Agenda
Village of Arlington Heights
Design Commission
Community Room, 3rd Floor
Arlington Heights Village Hall, 33 S. Arlington Heights Rd.
January 10, 2023
6:30 PM

Item: DC#22-073 - 1245 S. Arlington Heights Rd. - SF/Teardown

Item: DC#22-059 - 1518 N. Vail Ave. - SF/Teardown

Item: DC#22-080 - 1319 E. Clarendon St. - SF/New

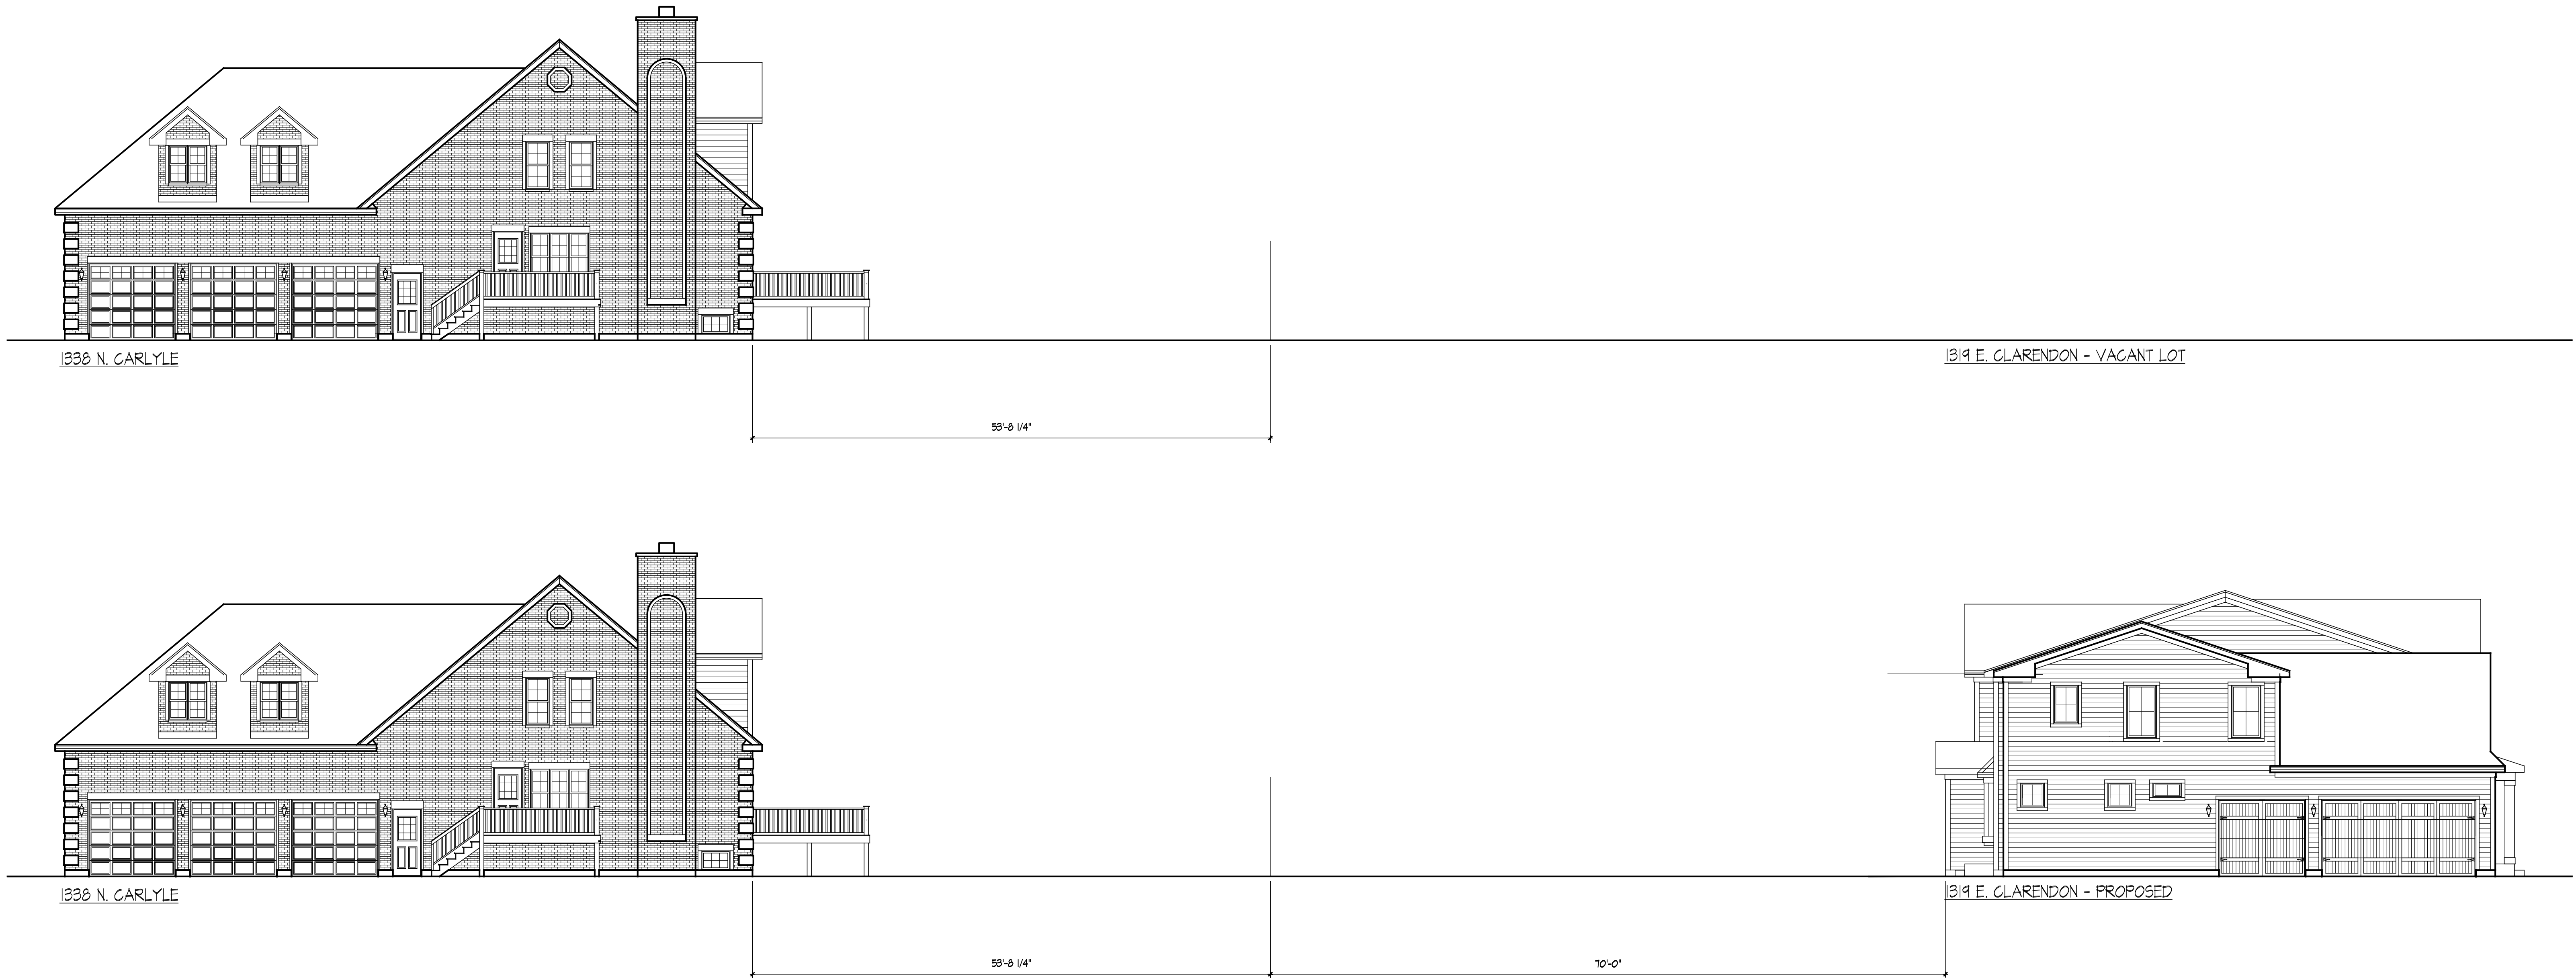
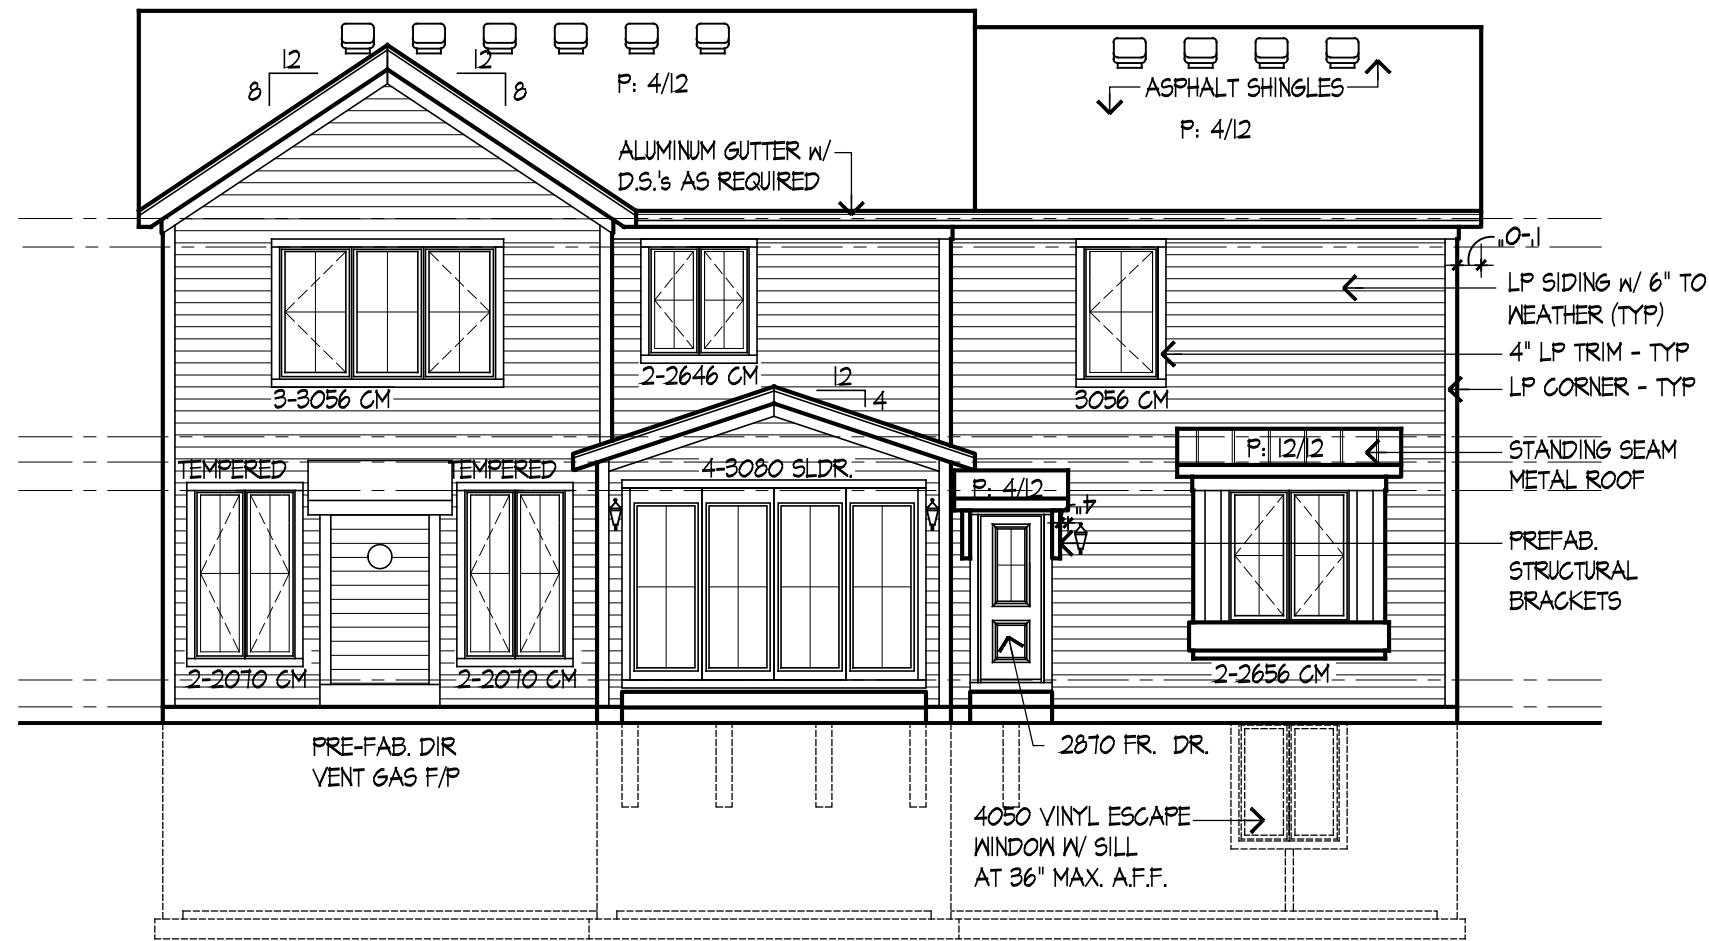
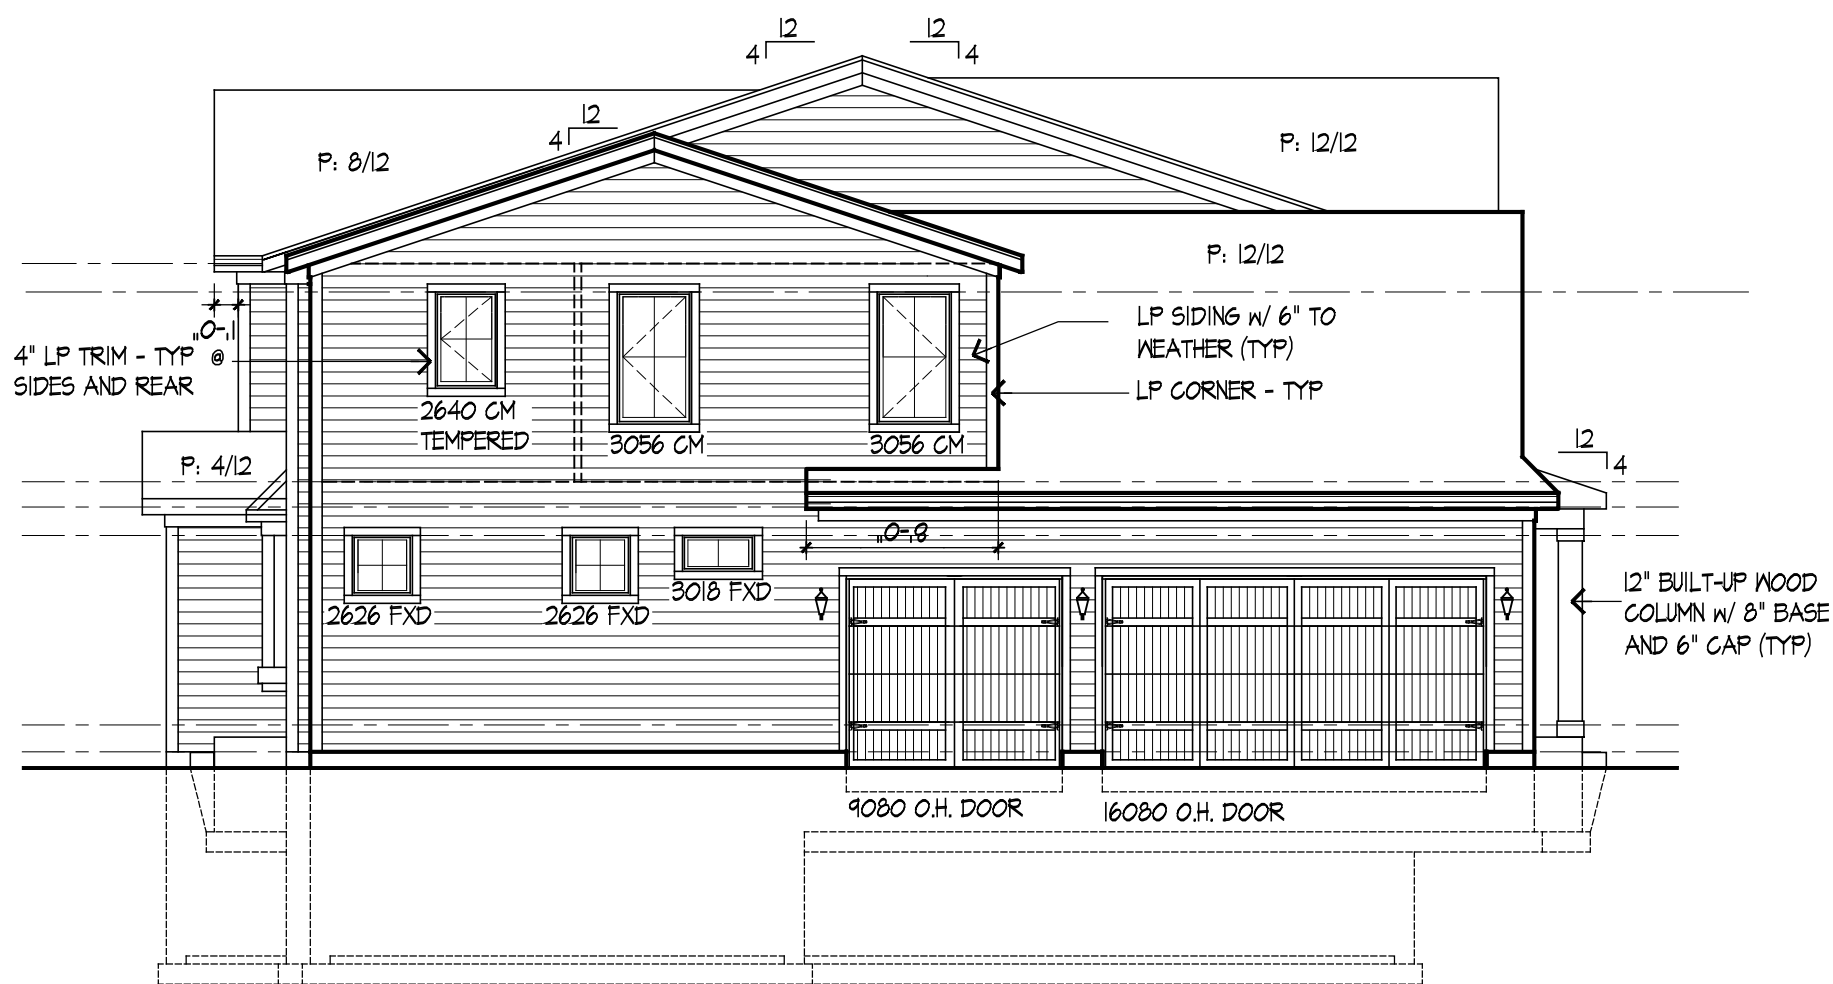
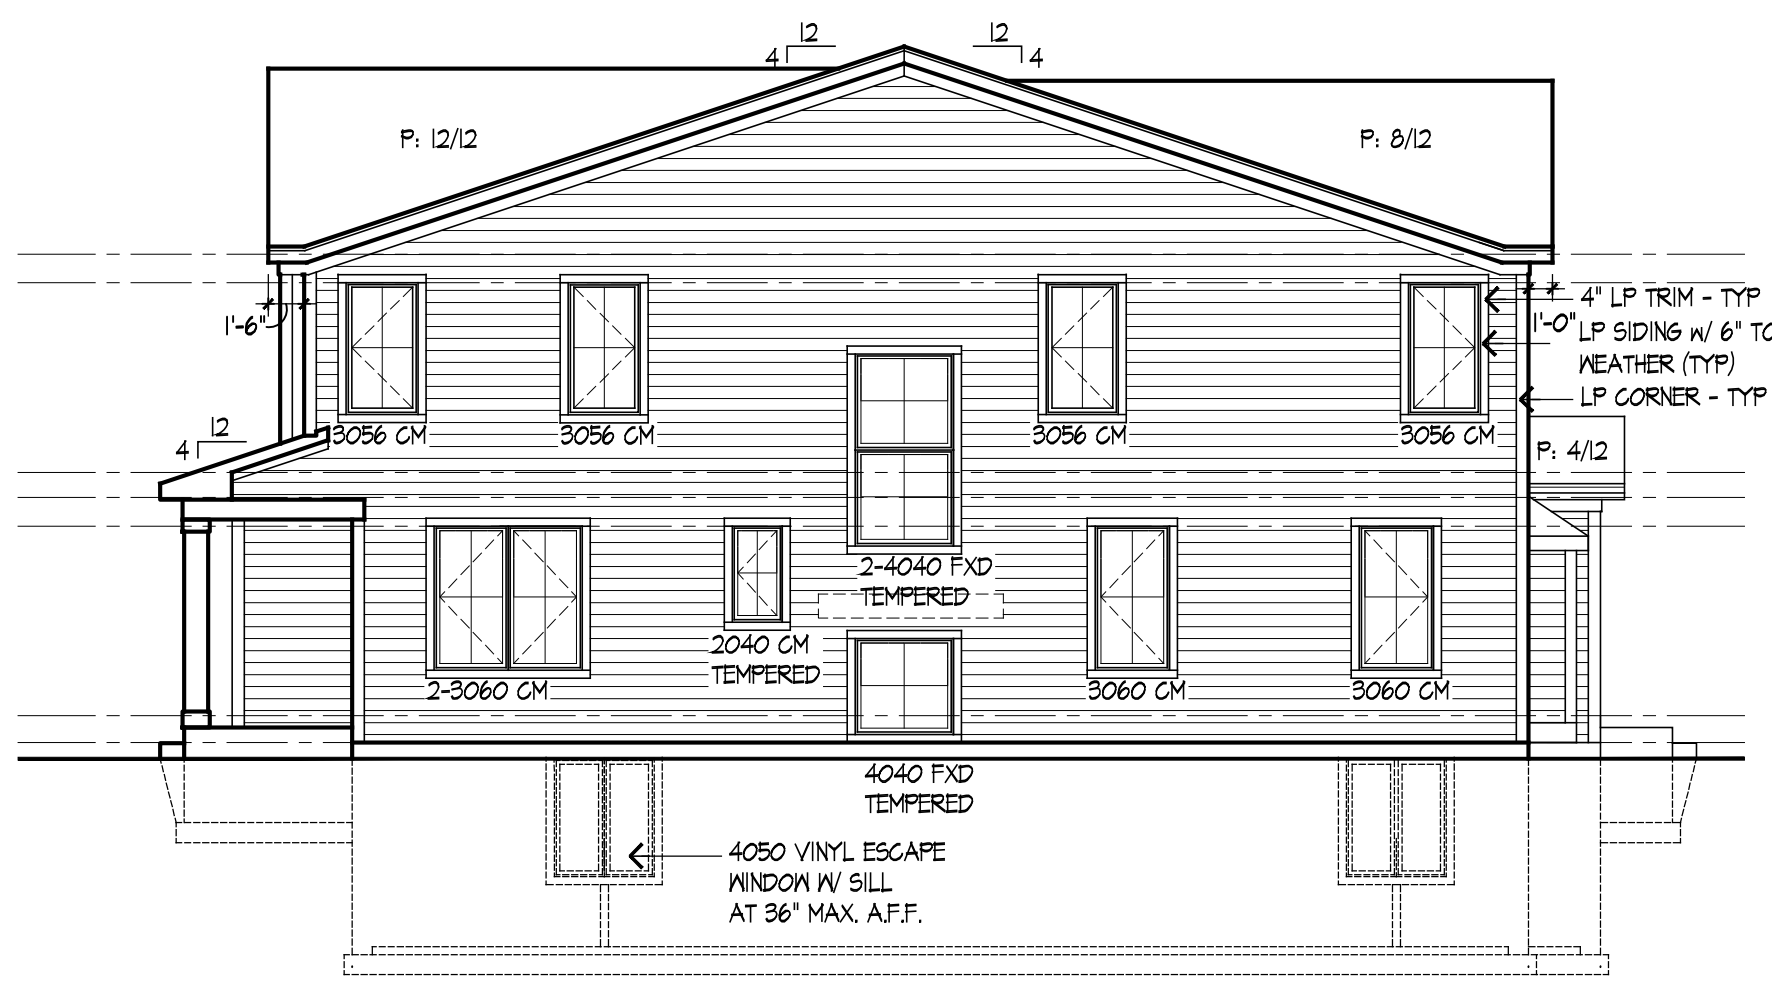
Overall, the proposed design fits well with the surrounding context which is primarily two-story homes with attached garages. The only comment about the design is regarding the prominent placement of the garage facing the exterior side. A better plan would place the garage on the interior side of the lot so that the living space of the house can be the focal point at the street corner instead of the garage doors. However, Staff does not object to the proposed garage placement since it fits well with the adjacent house to the south which has the same configuration of garage doors facing the exterior side. Suggestions to enhance the corner focal point are to add a box bay window on the garage front (north) elevation and a dormer above the garage doors on the exterior side (east) elevation.

1. Consider enhancing the corner focal point of the design with a box bay window on the garage front (north) elevation and a dormer above the garage doors on the exterior side (east) elevation.
